Access Compliance Report Public Rights-of-Way (Curb Ramps)

Main Street: CORONEL_RD Cross Street: ARROYO_AVE Location: SW

ADA ID: RPRK211013124358 Ramp Type: Type 4 - Parallel Initial Pass/Fail: Fail Overall Compliance: No Severity Score: 2

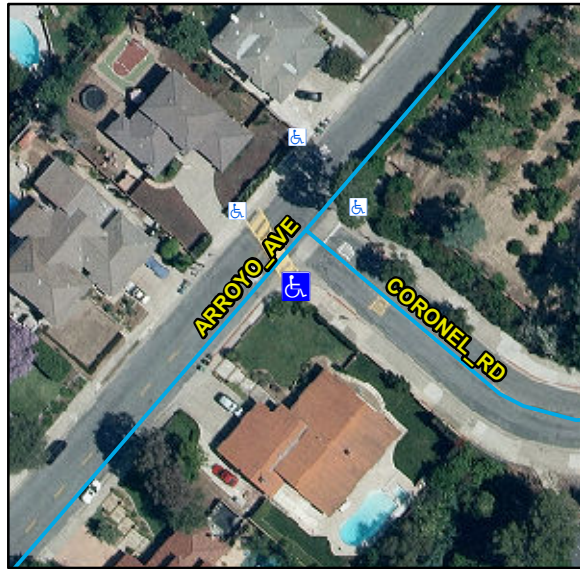
Compliance	Description	Data	Compliance	Description	Data
N/A	Ramp Length LT (in)	128	N/A	Ramp Length RT (in)	131
Yes	Ramp Width LT (in)	84	Yes	Ramp Width RT (in)	92
Yes	Ramp Run Slope LT (%)	5	Yes	Ramp Run Slope RT (%)	1.4
No	Ramp Cross Slope LT (%)	3.3	No	Ramp Cross Slope RT (%)	4.7
N/A	Landing Present	N/A	N/A	DWS Provided	N/A
N/A	Landing Length (in)	N/A	N/A	DWS Contrast	N/A
N/A	Landing Width (in)	N/A	N/A	DWS Length (in)	N/A
N/A	Landing Run Slope (%)	N/A	N/A	DWS Full Width	N/A
N/A	Landing Cross Slope (%)	N/A		DWS Offset Type	N/A
N/A	Landing Movement Obstructed?	N/A	N/A	DWS Offset Left (in)	N/A
	Landing Movement Type	N/A	N/A	DWS Offset Right (in)	N/A
N/A	Landing Shared	N/A			
N/A	Clear Space	Yes			
N/A	Clear Space To Crosswalk (in)	N/A			
N/A	Marked Crosswalk 1	No	N/A	Marked Crosswalk 2	Yes
	Crossing 1 Direction	NE		Crossing 2 Direction	NW
	Marked Crosswalk 1 Width (in)	N/A		Marked Crosswalk 2 Width (in)	144

N/A	Ramp Inside Crosswalk 1	N/A	N/A	Ramp Inside Crosswalk 2	Yes
	Crossing 1 Slope (%)	5		Crossing 2 Slope (%)	2.8
	Crossing 1 Cross Slope (%)	3.9		Crossing 2 Cross Slope (%)	4.3
N/A	Gutter Ponding	N/A	Yes	Curb Slope	0.1
No	Gutter Lip Height (in)	0.5		Road Run Slope (%)	4.6
N/A	Gutter Run Slope (%)	N/A		Road Cross Slope (%)	2.6
N/A	Gutter Cross Slope (%)	N/A	No	Perpendicular Joint Present	No
Yes	Overall Surface Condition	Acceptable			
	Cross Gutter Present?	Yes		Spandrel Present?	Yes
	Replace Cross Gutter?	No		Replace Spandrel?	No

Remove & Replace Curb Ramp With Two New Directional Ramps or Equivalent. Grind Gutter Lip.

R204.3, R304.5.3, R302.7.2, STD 1115
